**Re: Submission of Part 573 Report; Recall of Utilimaster Aeromaster
Walk-In Delivery Vans Built on Ford Chassis**

04V-511
(6 pages)

Ford Heel Plate Removal Recall Campaign Directive

**Step 1: Remove 8.5" x 8.5" Heel Plate
(Before)**

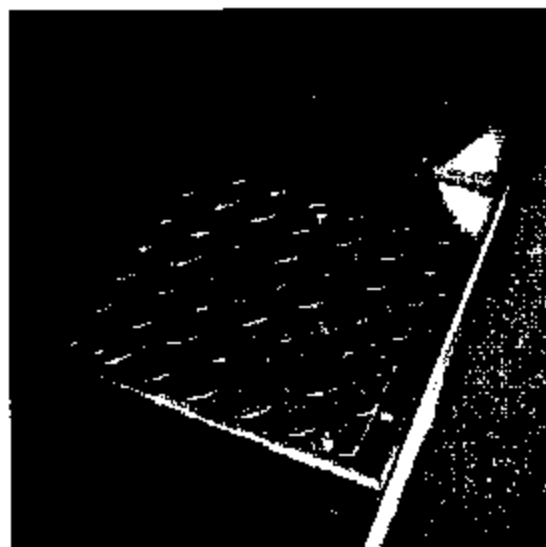
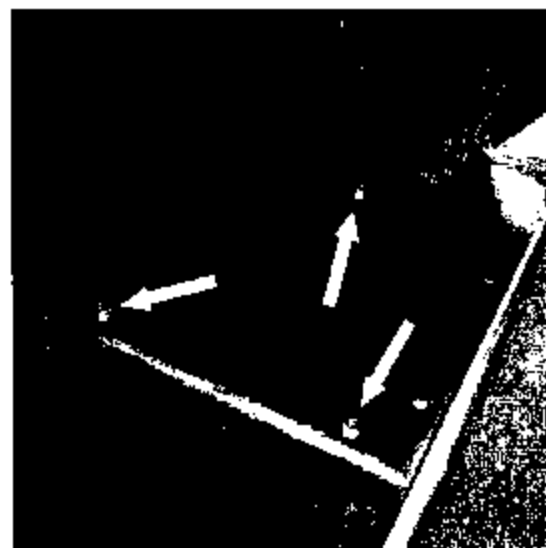
SITUATION: On some Ford Aeromaster bodies built by Utilimaster, the optional heel plate (treadplate/diamond plate) limits the full movement of the accelerator pedal.

CORRECTION: If your vehicle has the 8.5" x 8.5" aluminum heel plate option, remove it. See illustrations.

**Step 2: Replace Original Fasteners
(After)**
